SUBJECT : Hyundai IT CORP.
FCC ID: PJILT26AW001
FCC Part 15 Subpart B Certification

Transmitted herewith, on behalf of Hyundai IT CORP. is an application for a Class II Permissive Change Certification of the following 26-inch LCD TV Monitor:

FCC ID : PJILT26AW001
Type No. : LT26AW001

•Solution for EMI

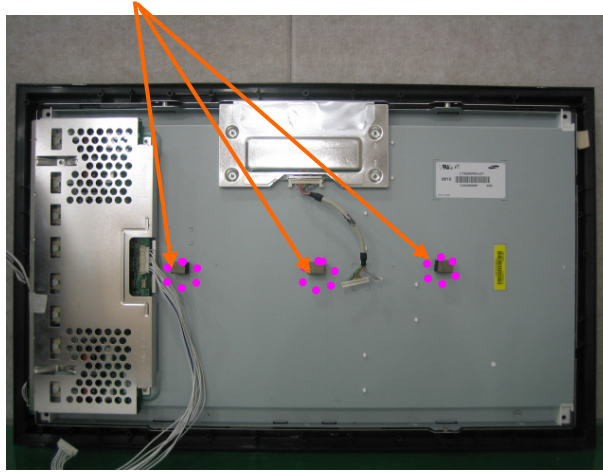
1. Attach a gasket on the Rear frame.

2. Attach aluminum tape on the main board to contact the main frame.

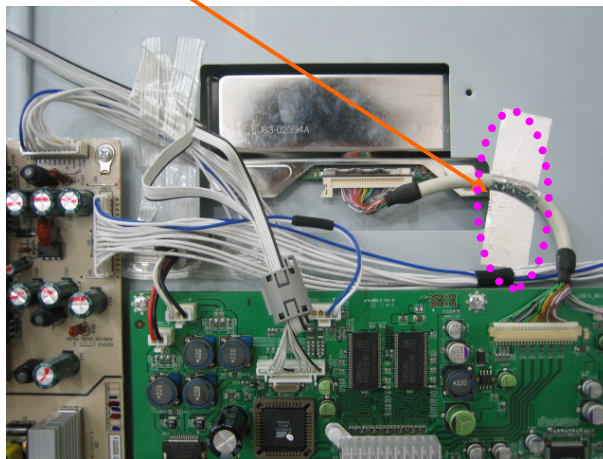
3. Apply a ferrite core to the cable.
